Petition No. 1222  
Interrogatories  
Set One  
April 14, 2016

Windham Solar LLC (WS) Responses April 28, 2016

**FISK ROAD SOLAR**  
 390 HARTFORD TURNPIKE  
 HAMPTON, CT 06247  
 WINDHAM COUNTY

**OVERALL SITE PLAN**

**Towns with  
Aquifer Protection Areas**

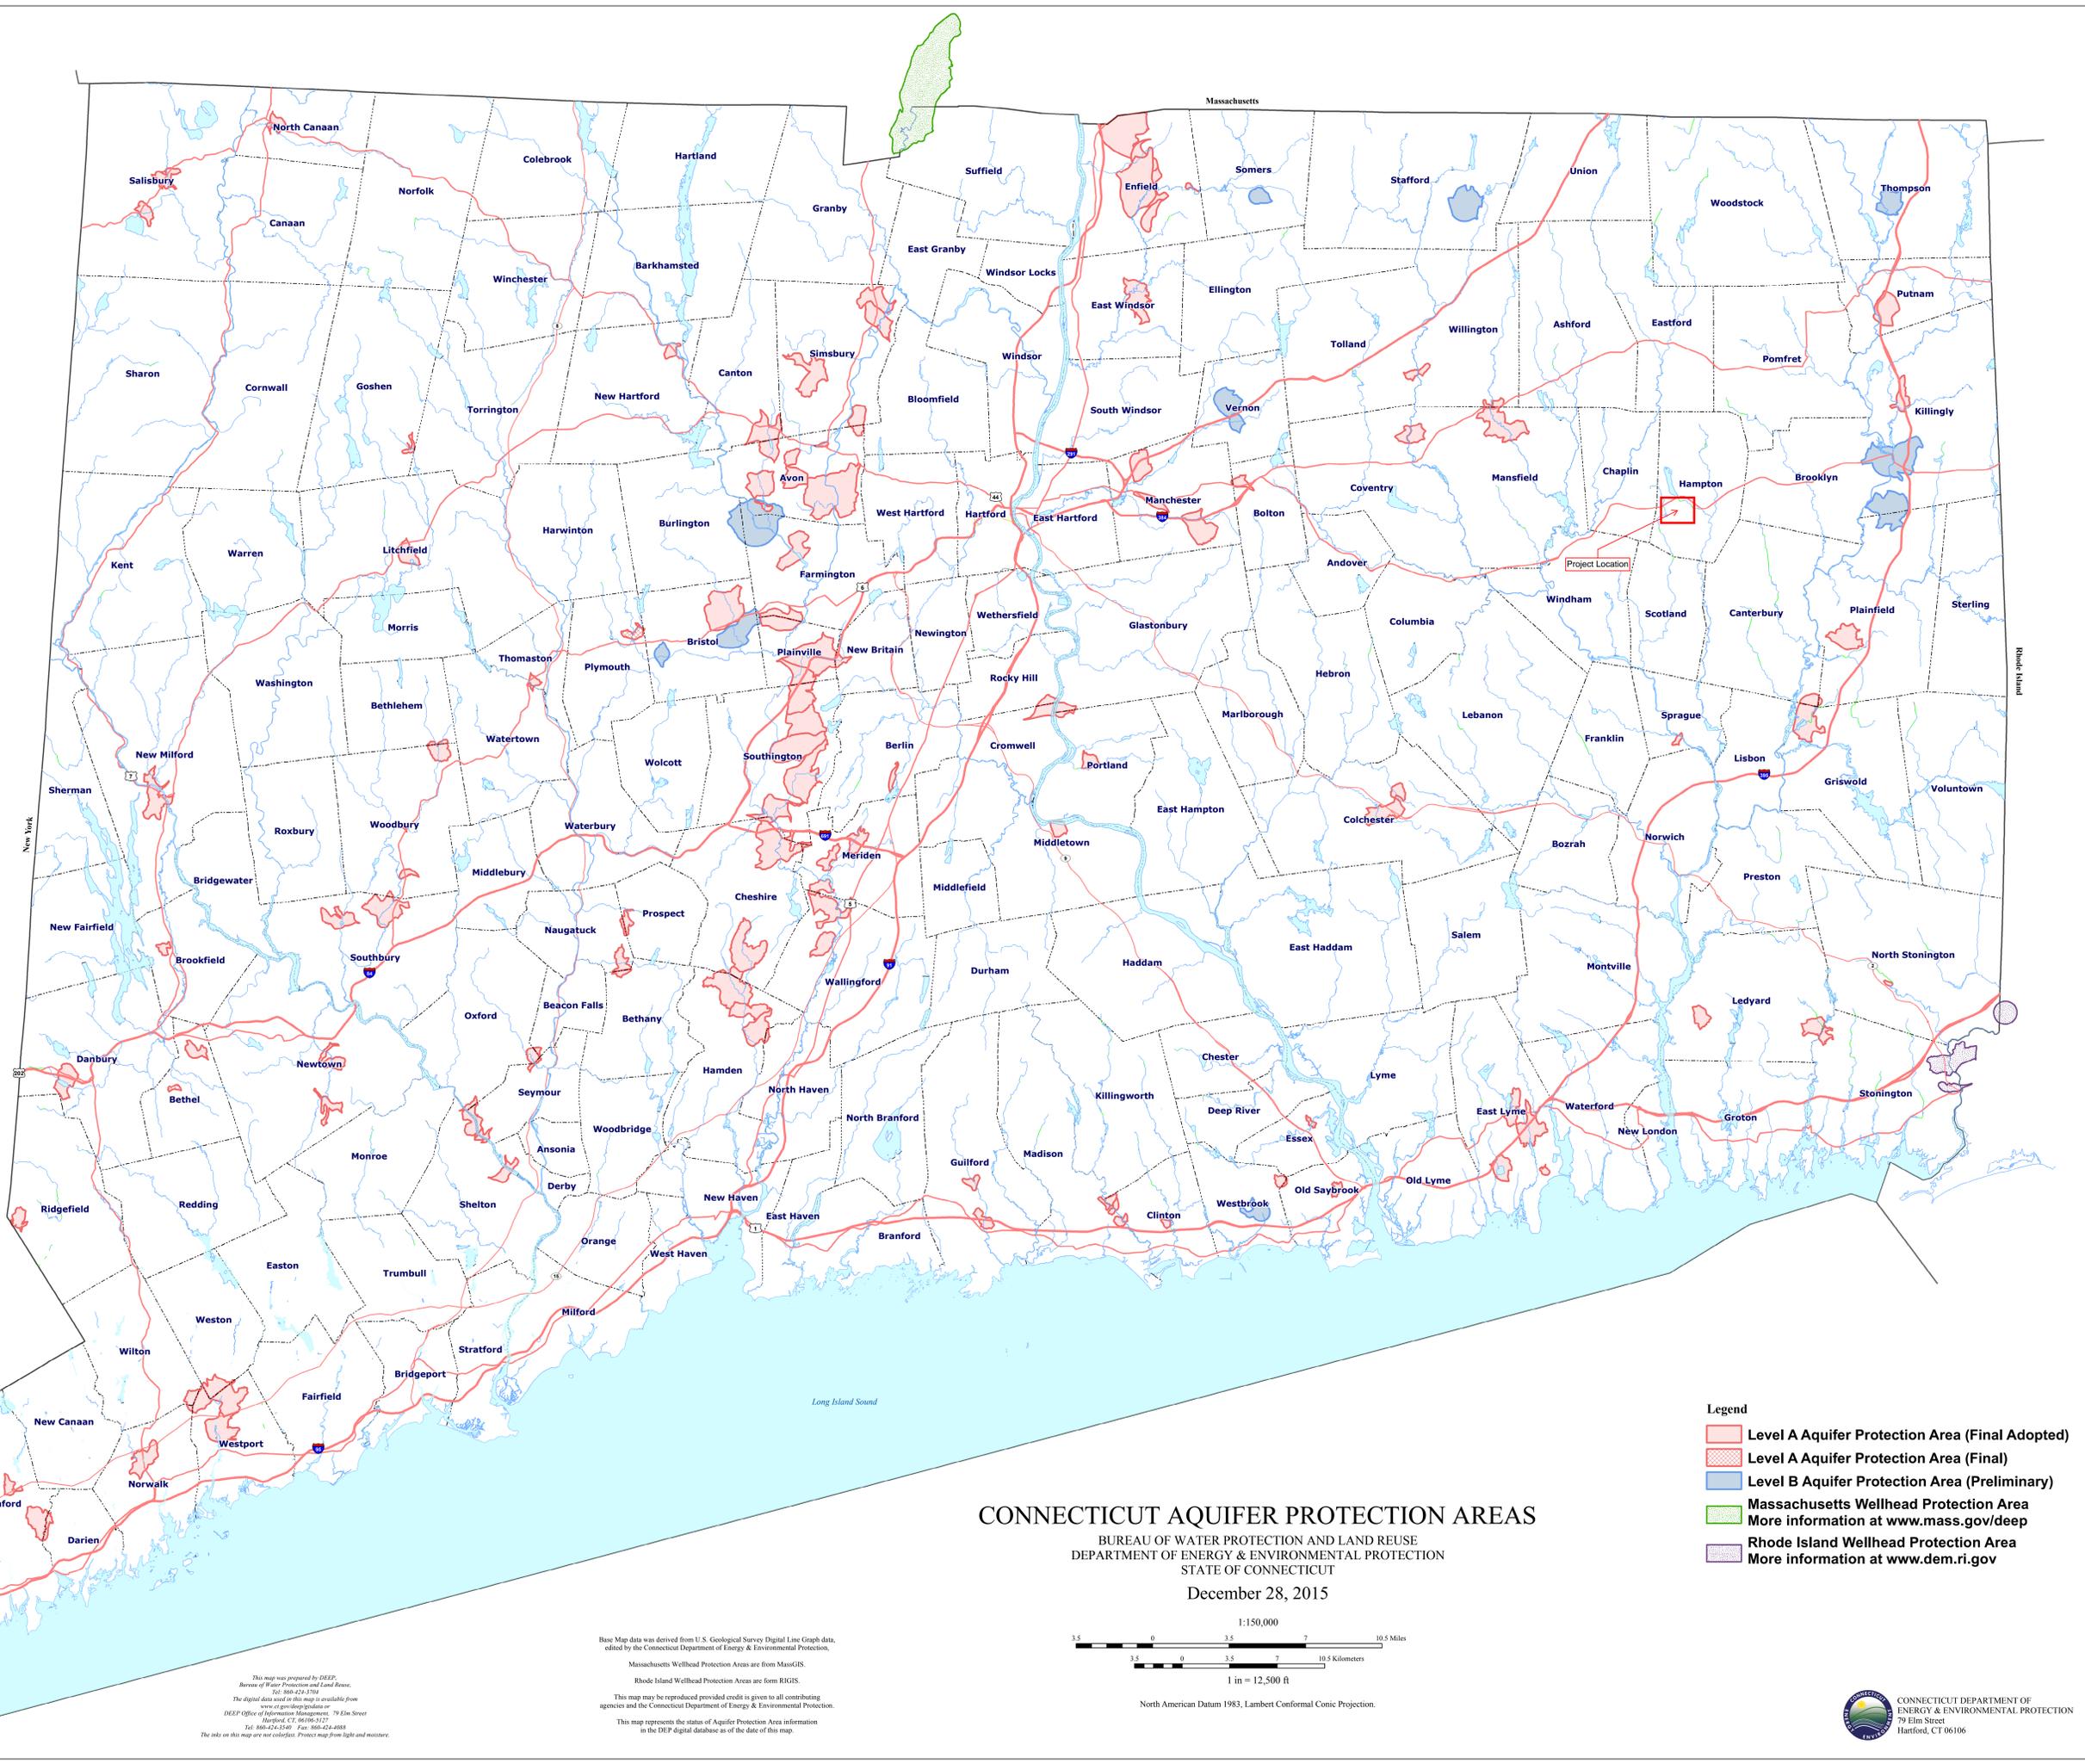
25. Is the proposed project located within an aquifer protection area?  
No, the town of Hampton has not adopted an aquifer protection Area, the overall state map has been attached and the site has been identified. - Exhibit F
